REVIEW OF THE McARTHUR RIVER MINE OPEN CUT PROJECT PUBLIC ENVIRONMENTAL REPORT

By
Professor Wayne D. Erskine
Centre for Sustainable Use of Coasts and Catchments
School of Environmental and Life Sciences
University of Newcastle – Ourimbah Campus
PO Box 127
Ourimbah NSW 2258

July 2006

Figure 3. Sand deposits in the channel of the upstream anabranching reach of the McArthur River. (W.D. Erskine photographs).

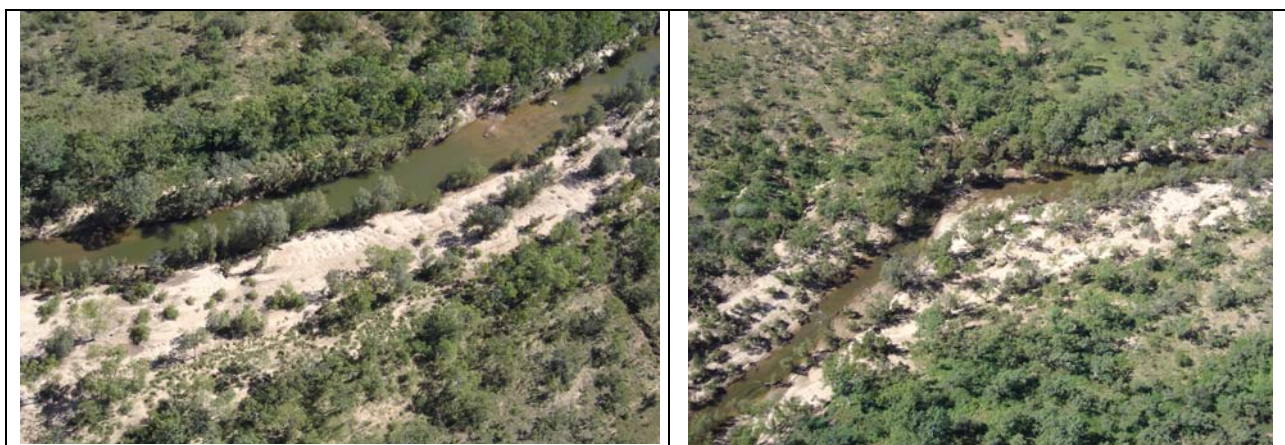
Erskine (2006) predicted that upstream progressing degradation will occur upstream of the diversion channel because of the very high specific stream power. The Draft EIS did not discuss whether bedrock was exposed in the channel boundary where the HEC-RAS model indicated that there were very high specific stream powers. Armouring is a natural self-stabilising tendency of rivers which selectively erodes the finer sediment in the bed material and concentrates the coarser sediment on the bed surface. Gravel armour layers produced by bed degradation are monolayers that coat and hence protect the finer underlying sediment from erosion. The Draft EIS did not investigate armour layers. My initial concerns have been reduced because bedrock is exposed in the channel bed at sites of high specific stream power and a significant gravel fraction is present in many sections of channel in the upstream anabranching reach (see above).

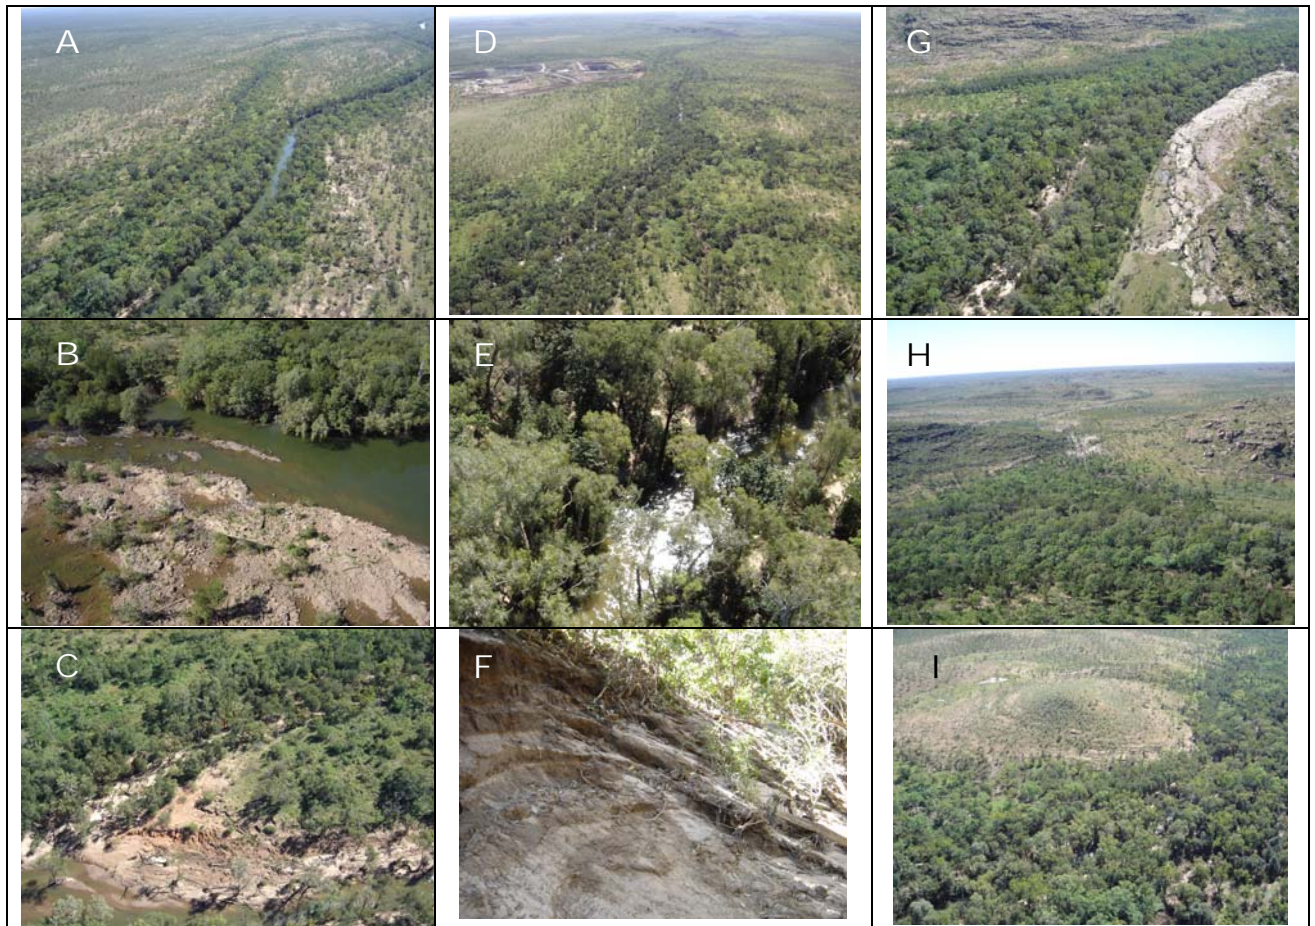
While URS (2006) concluded that the channel of the McArthur River was stable upstream of the entrance to the diversion channel in the anabranching reach, there are pockets of bank erosion (Figure 4C). These pockets seem to occur where there are gaps in the riparian vegetation due to flood disturbance and/or grazing damage or where there are channel bifurcations around islands or where there are locally steeper sections over bedrock bars. The channel is not as active as originally expected (Erskine, 2006) because

of the often dense riparian vegetation and the multiple bedrock bars. Nevertheless, the channel is also not as stable as suggested in URS (2006).

Figure 5. Natural levees in the upstream anabranching reach eroded by rilling and gullying of dispersible/slakeable soils (W.D. Erskine photographs).

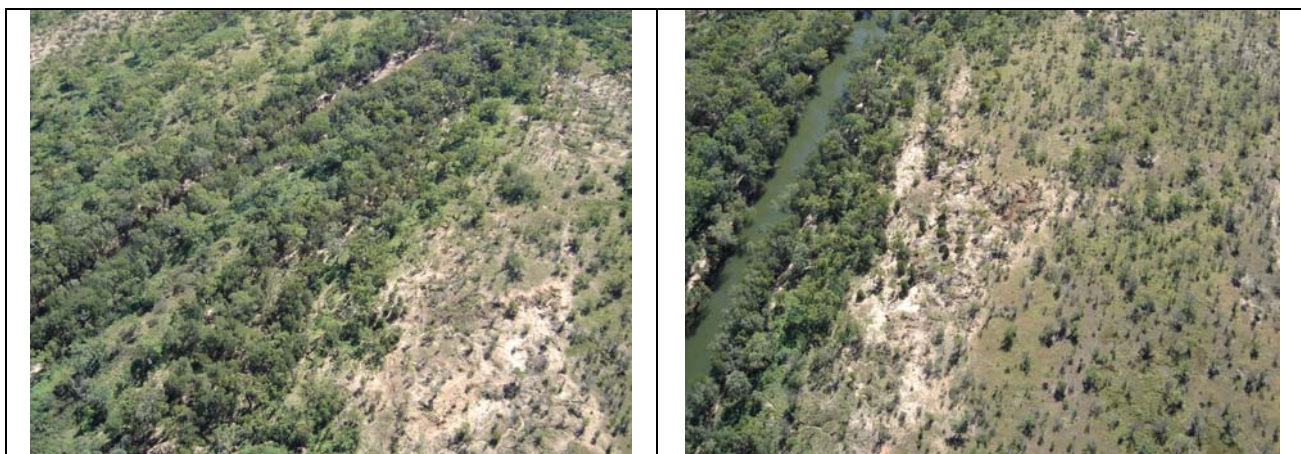
justify calling the existing channel near the mine as stable (see URS, 2005a, Appendix K, p. K-24). The representativeness of a single piece of site specific data is always a concern. By itself, it is not helpful. As noted in URS (2006), aerial inspection of the upstream anabranching reach revealed numerous bedrock bars in the bed of the main channel and occasional sections of bank erosion (Figure 4C). Furthermore, high parts of the floodplain were also eroded by rilling and gullying and appeared to be associated with overgrazing of dispersible/slakeable soils (Figure 5).
